**ADDENDUM # 1**

RE: **Pay Item Change, Installation Guidance Exhibits Provided,  
Question & Answer, Pre-bid Meeting Minutes and Sign-in  
Sheet**

Contract ID: DN00546  
County: Transylvania  
Letting Date: March 14, 2017

DESCRIPTION: Barclay Road (SR 1207) and Wilson Road (SR 1540) GR replacement upgrades  
SUBJECT: Mandatory Pre Bid Meeting Minutes

## ■ Design Standards – Index 400

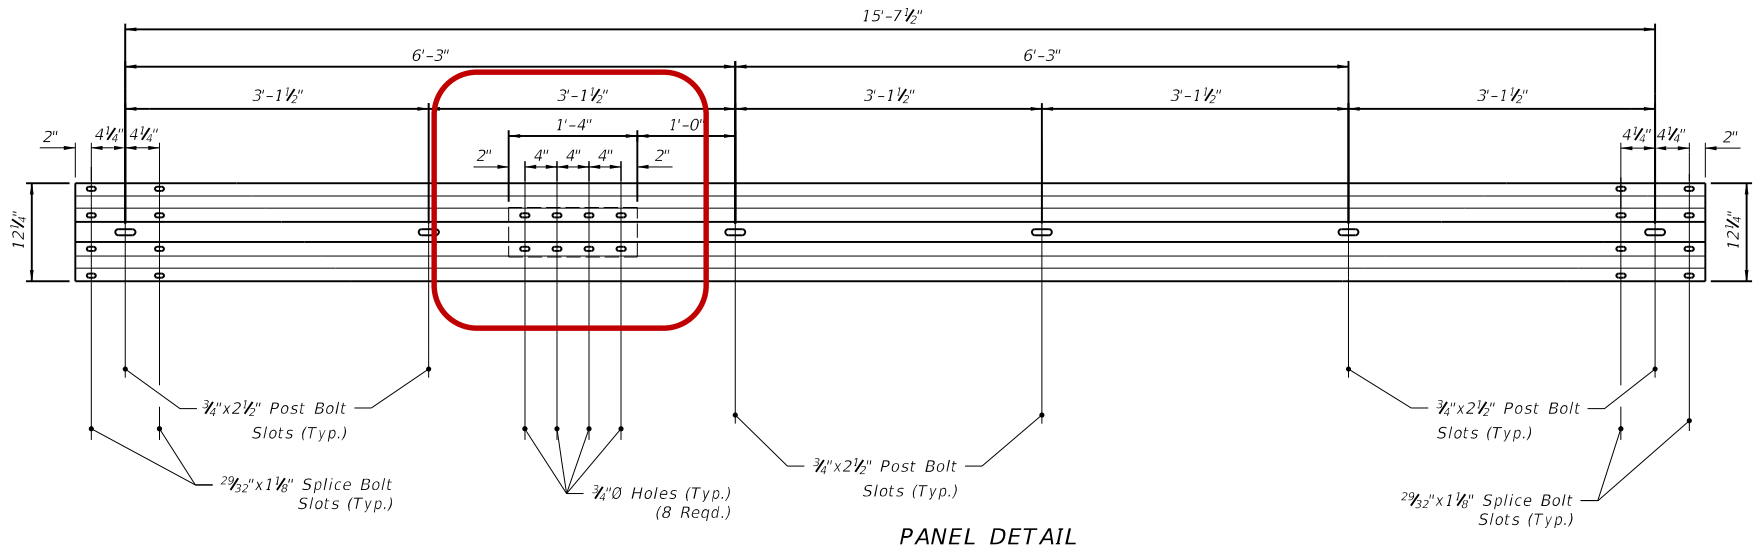
Summary of Major Changes to Guardrail			
Criteria	Existing	New	Sheet Number
End Anchorage Assembly Type II Or Type CRT	Required a 12'-6" W-Beam End Anchorage Panel with Beam Anchor Plate Attachment	Requires a 15'-7 ½" W-Beam End Anchorage Panel with Beam Anchor Plate Attachment	20D and 23A
Approach End Anchorage Assemblies Flared and Parallel	End Anchorage Assembly Flared 50'-0" Parallel 37'-6" Assembly Length	End Anchorage Assembly Flared 53'-1 ½" Parallel 53'-1 ½" Assembly Length	2
Guardrail Height Transition from 27" to 31"	1'-9" Mounting Height	2'-1" Mounting Height	13B

## ■ End Anchorage Assembly Type II (Elevation View)

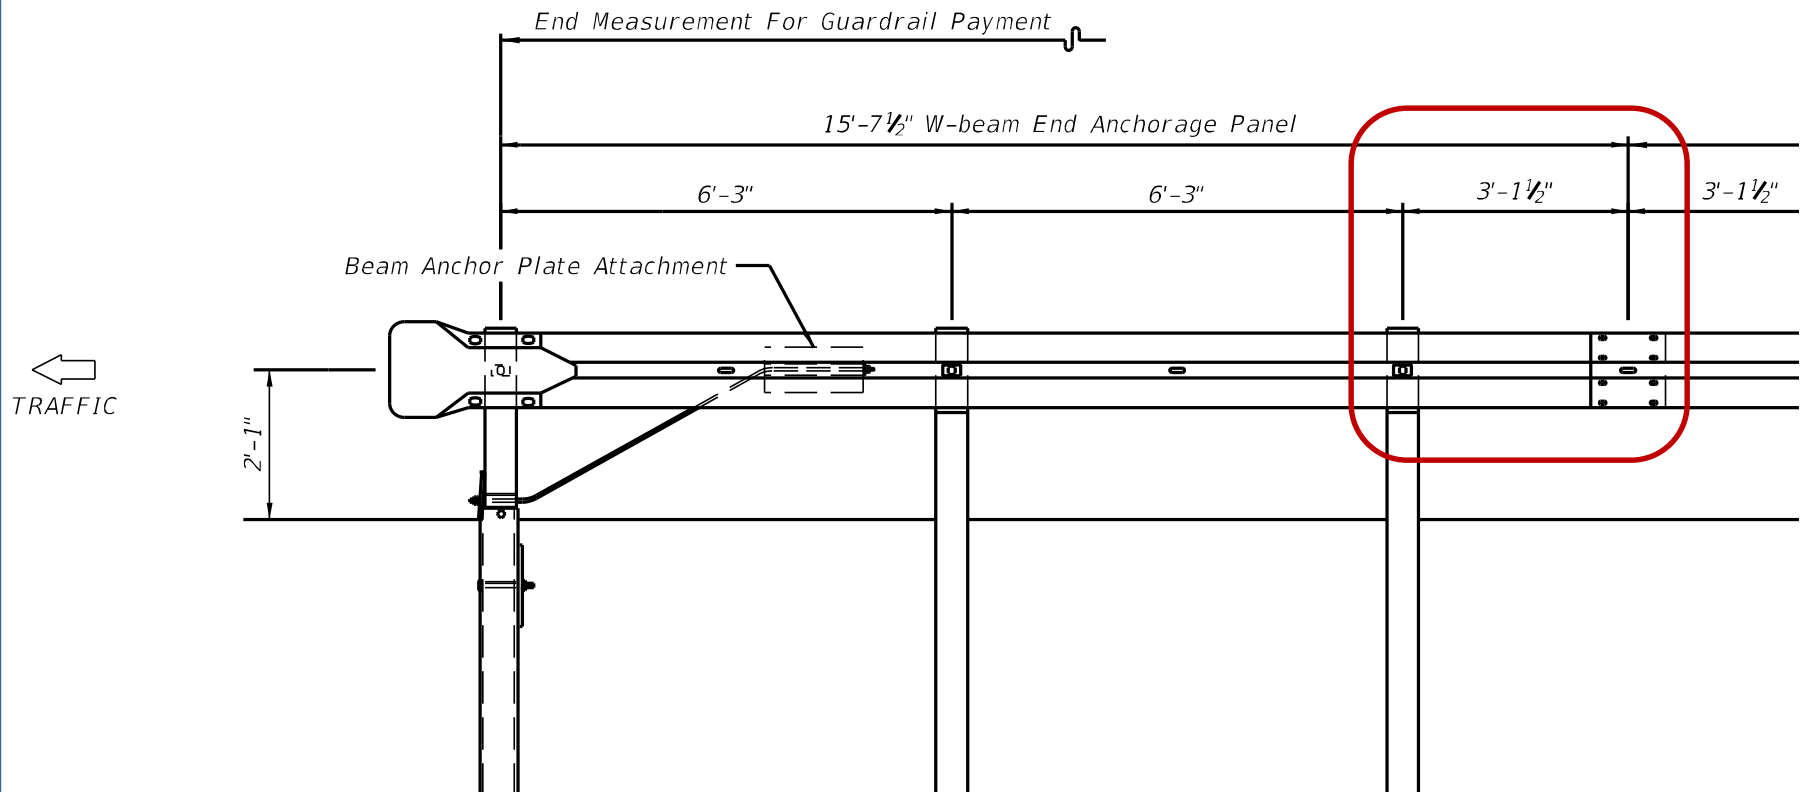
Account for the Added 3'-1 1/2" Panel Length in your Length of Need (LON) Calculations

## ■ Approach End Anchorage Details (Flared 53' - 1 ½'')

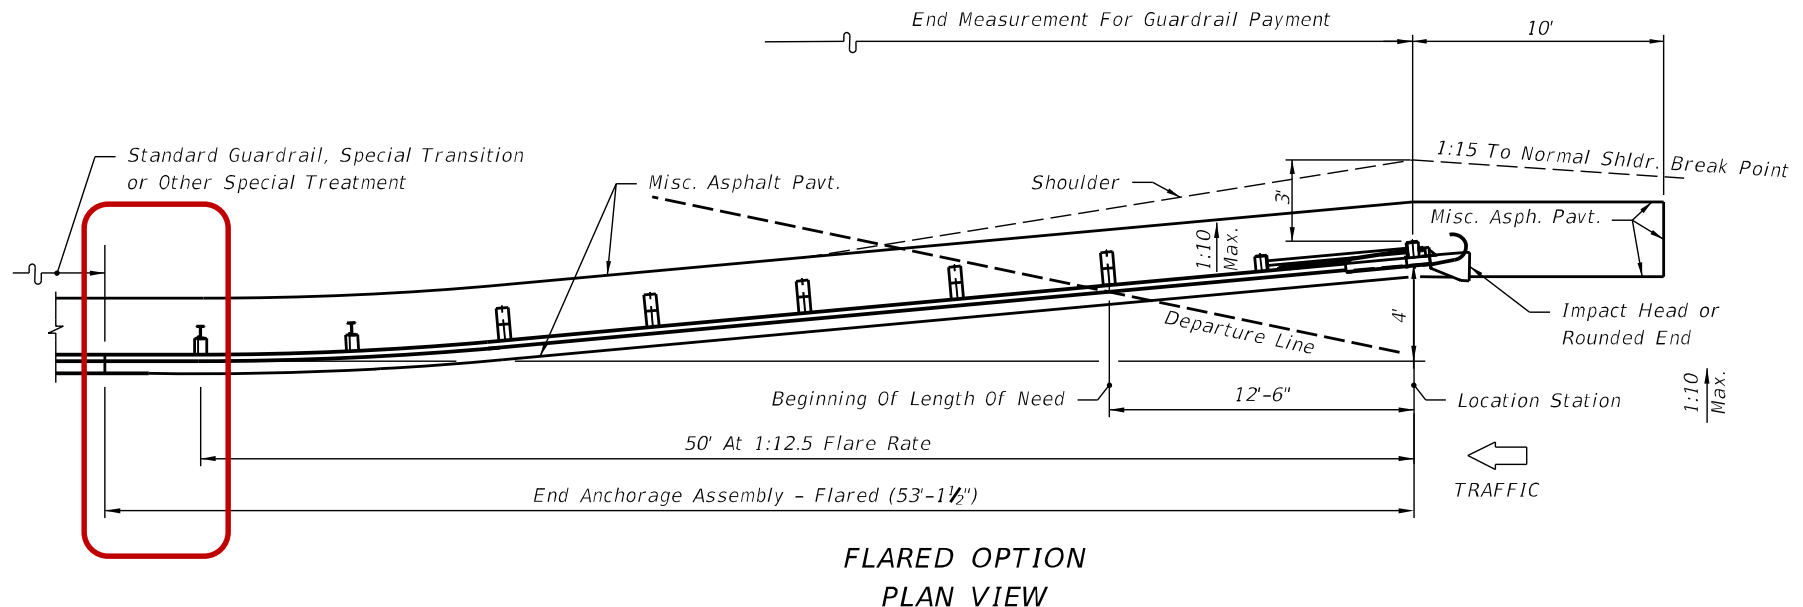
Account for the Added 3'-1 ½'' Panel Length in your Length of Need (LON) Calculations

## ■ Approach End Anchorage Details (Parallel 53' - 1½")

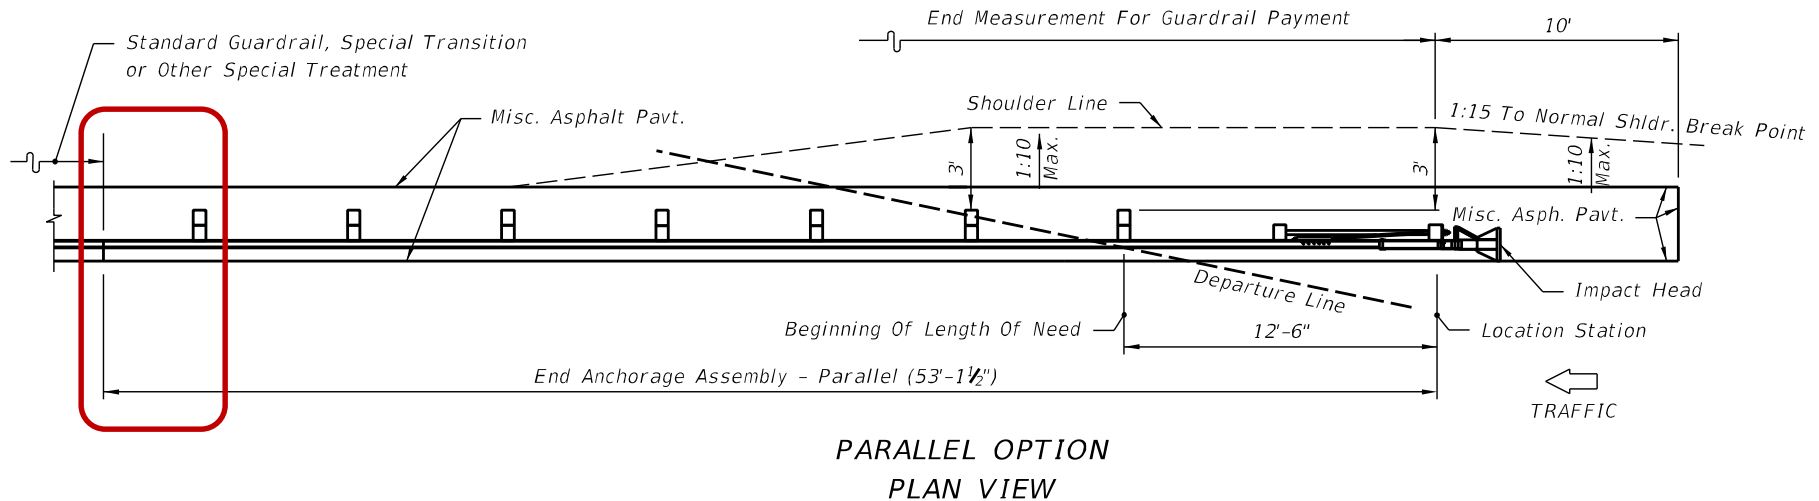
Account for the Added 3'-1½" Panel Length in your Length of Need (LON) Calculations

## ■ Guardrail Mounting Height Transition Detail

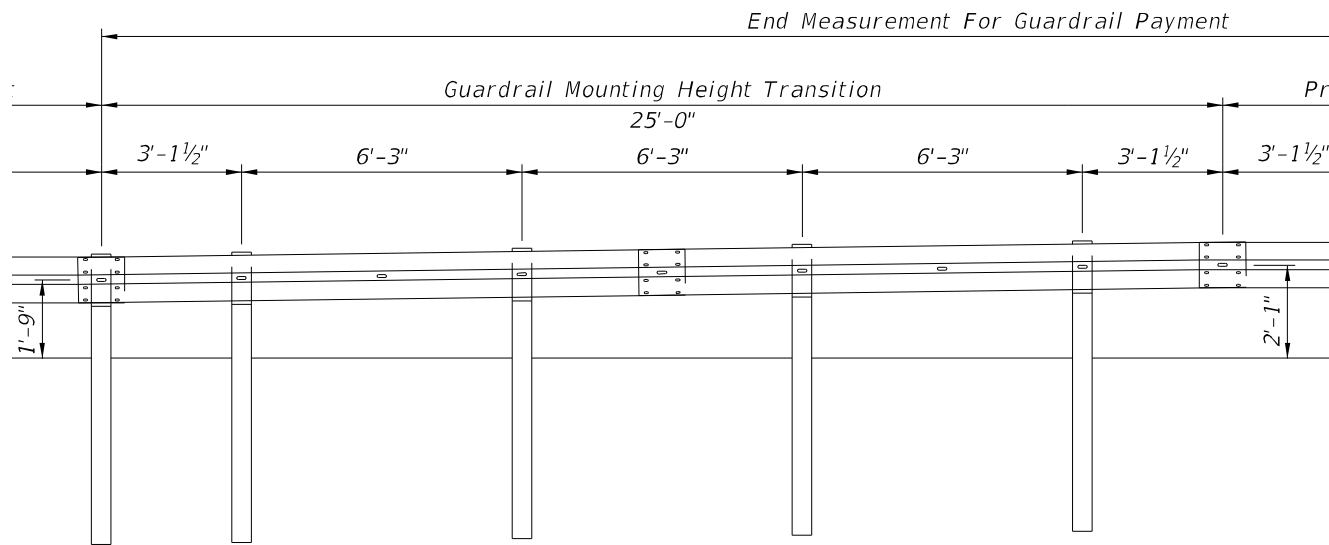
Transition from 1'-9" to 2'-1" W-Beam Guardrail Mounting Height

Shall be Used to Transition at the Begin and End Project Limits or in Special Cases As Directed by the Engineer
